SERVICE Counselor

PACKARD MOTOR CAR COMPANY

APRIL, 1953

Ultramatic Planetary Assembly Balanced

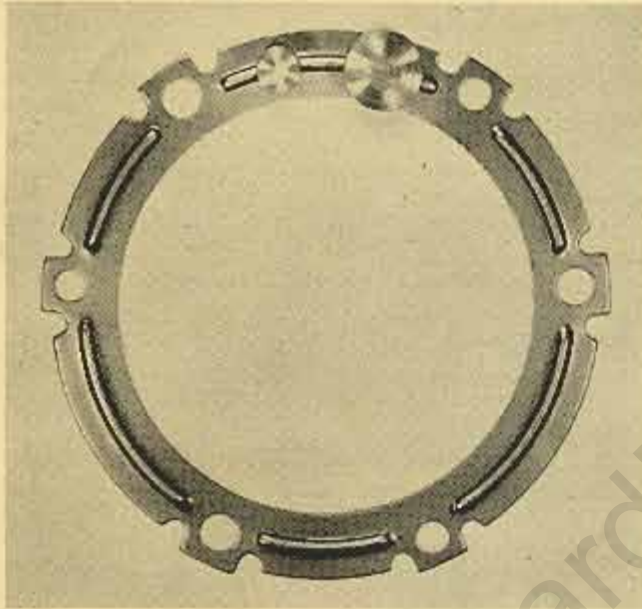
All 26th Series Ultramatic transmissions starting with transmission serial numbers 84130, 221200 and 26331 will have the planetary assembly balanced as a unit.

The balancing weights are of two sizes and are spot welded to the planetary cage bolt lockplate, "See Illustration." One or more weights may be found on one lock plate.

In some instances a planetary assembly may be found without balancing weights, but will have a star stamped on the outside of the planetary cage. The star indicates that the planetary assembly is in balance and does not require any weights.

When disassembling a balanced planetary assembly, it is very important that the lockplate be marked with a scribe or prick punch so that it will be re-assembled on the planetary in the same location before it was removed.

Temperature Gauge Reading

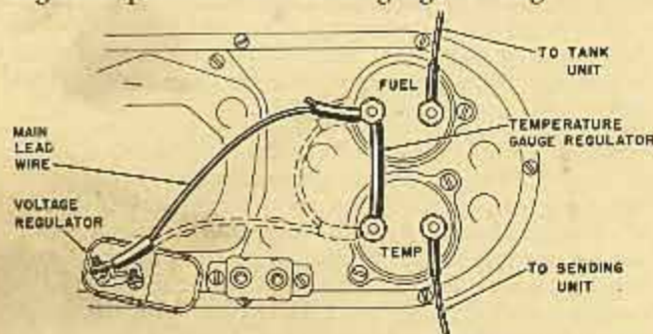
We have received a few reports from owners where they complain of coolant overheating but it does not actually boil. They state that the temperature gauge reads much higher than on other cars they have owned.

Similar reports from the field state that the temperature gauge reads on the hot side but when the coolant temperature is taken with a thermometer, it is found to be normal.

Beginning with 26th Series production (approximately 6000 cars), a temperature gauge regulator is attached to the gauge as shown in the illustration. The regulator provides an accurate gauge reading.

Starting with Engine Numbers L-202588, L-301595, L-401245, L-600503, the regulator was discontinued and a new re-calibrated sending unit is used. The electrical wiring hook-up used with the temperature gauge regulator is shown in the illustration. The dotted lines indicate the wiring hook-up used without the regulator.

When it is found that a temperature gauge reads high on 24th or 25th Series cars and there is no loss of coolant or a boiling condition, the gauge is giving an improper reading due to improper resistance in the gauge wire circuit. A correct gauge reading can be obtained by installing the new sending unit.

Caution: Under no circumstances should the new re-calibrated sending unit be used on cars having the gauge regulator.

The temperature gauge regulator is available for service replacement on the early 26th Series cars and can be ordered under Part Number 436586.

The new re-calibrated sending unit is available for service replacement on the 24th, 25th and late 26th Series cars and can be ordered under Part Number 439368.
